Addendum #3

Project: 20240606 - BL000A Site - Replace Section of 12470V Circuit 104 and 106

Date: December 11, 2025

Drawing Sheet E6

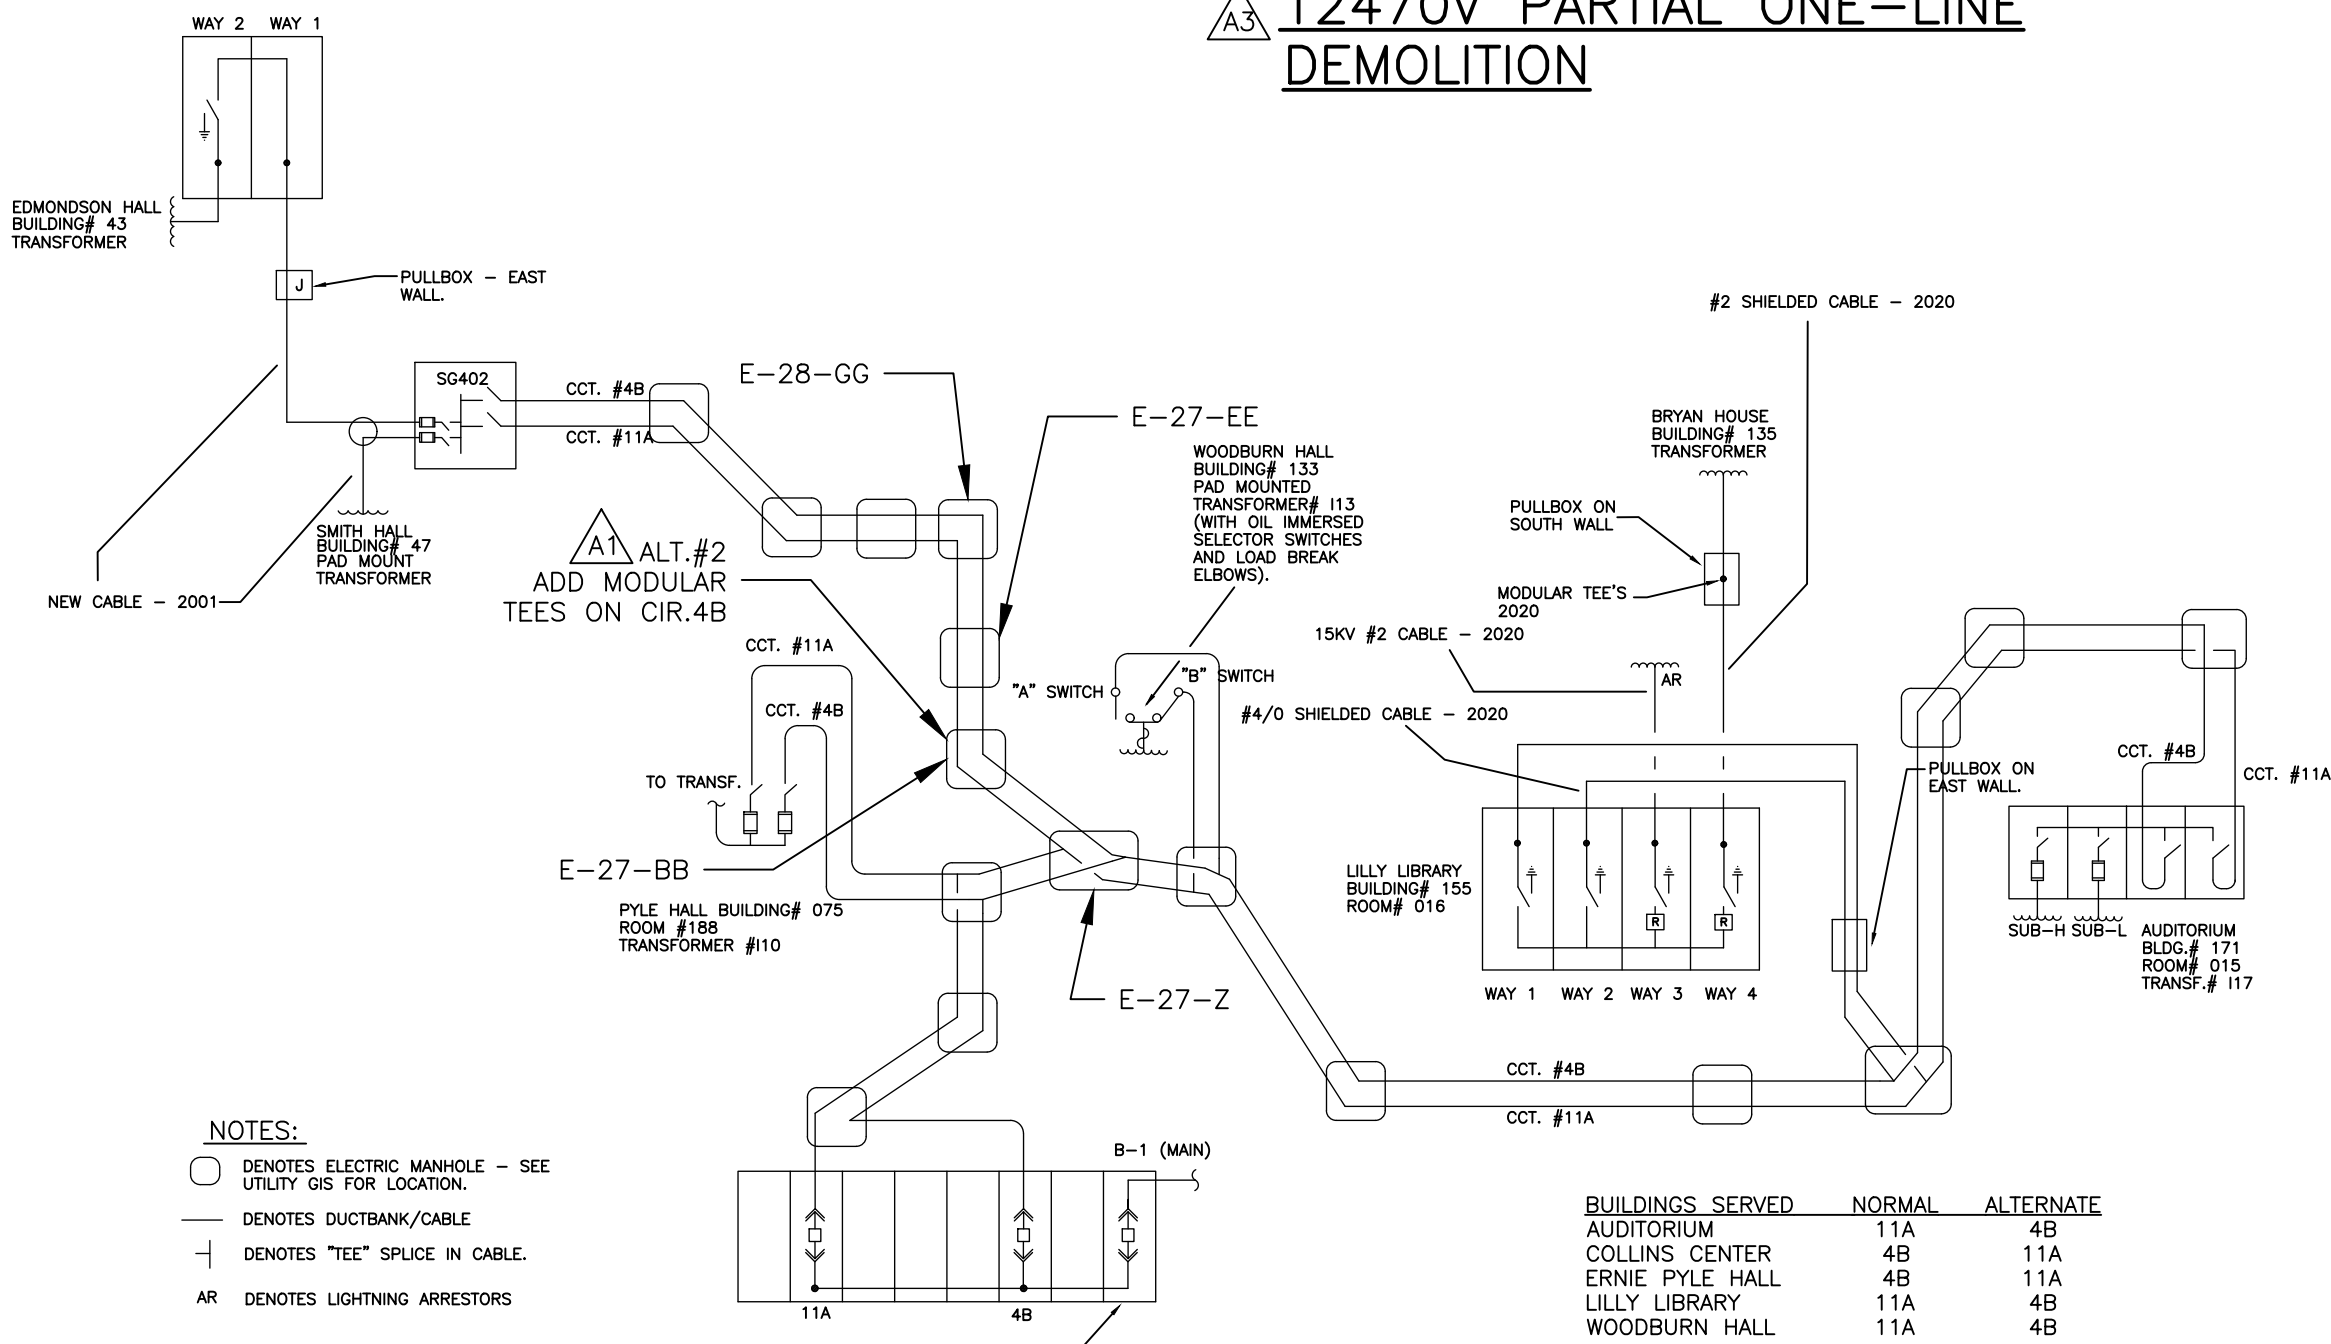
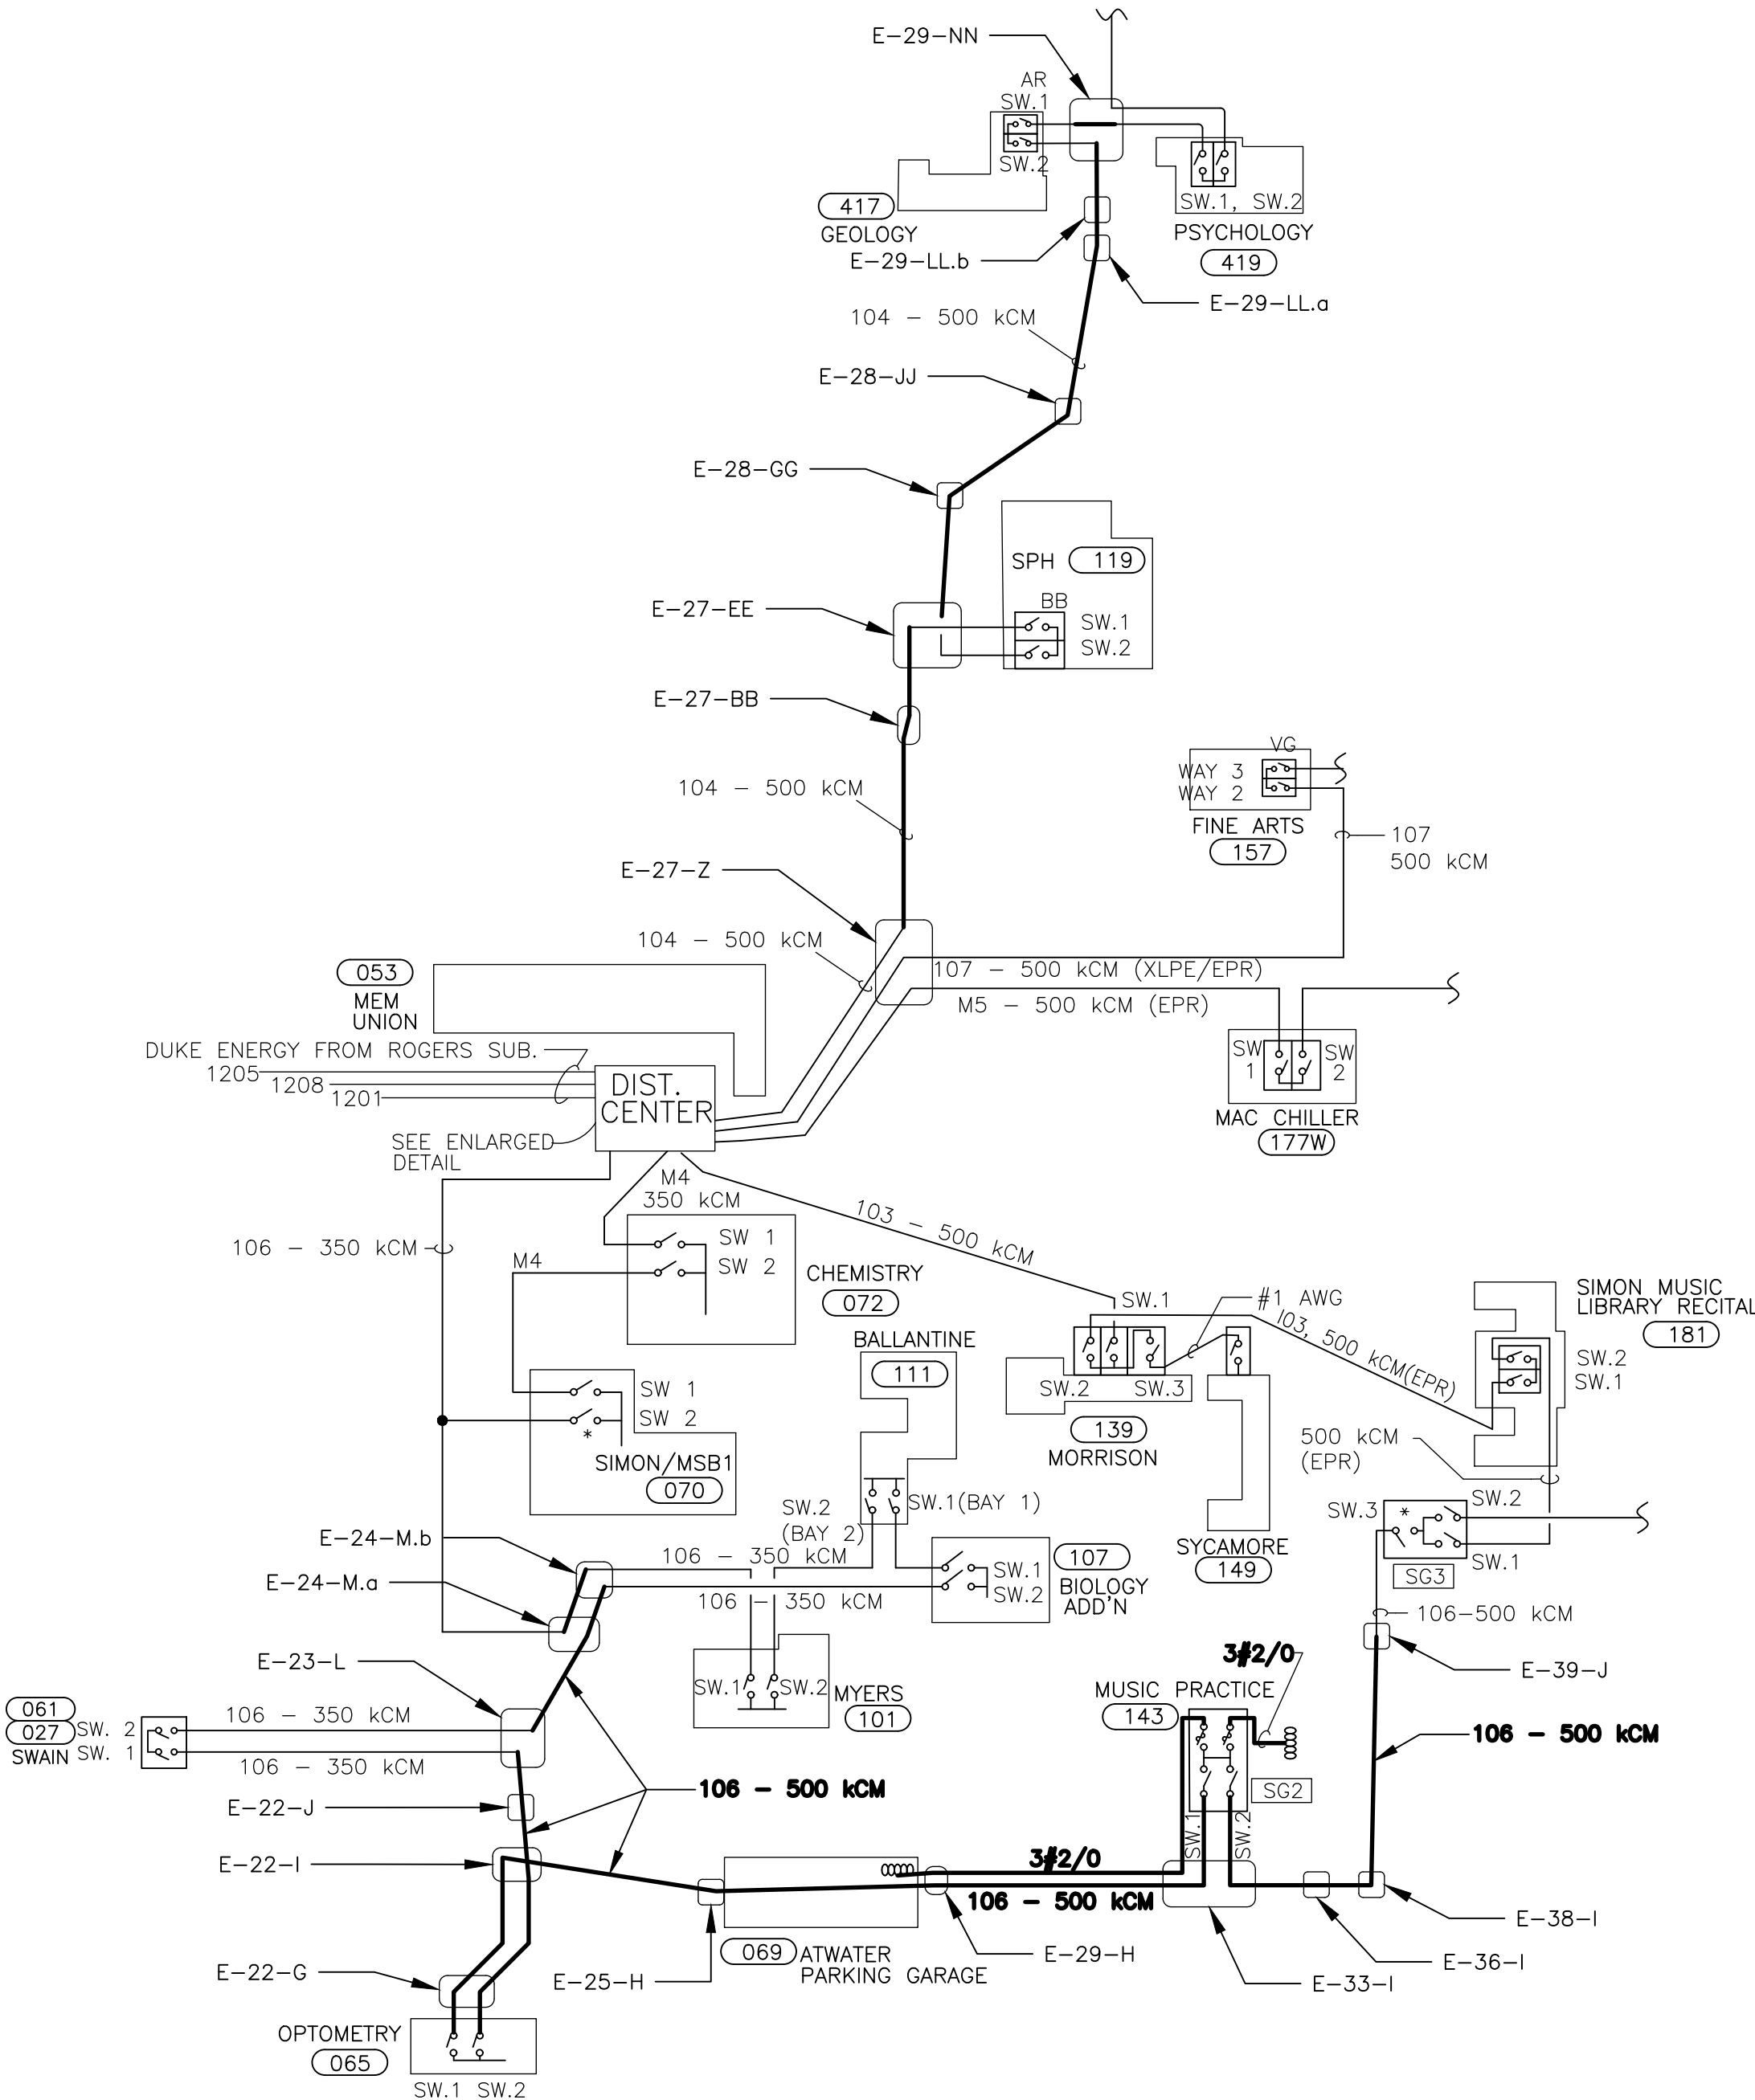
- Q5. One line drawing and site plans seem to be contradicting each other particularly around the detail of manhole 24 Simon and Myers building. And can you mark the manhole locations on the one line?
A5. Yes, the circuit diagram has been updated and is included in this addendum.
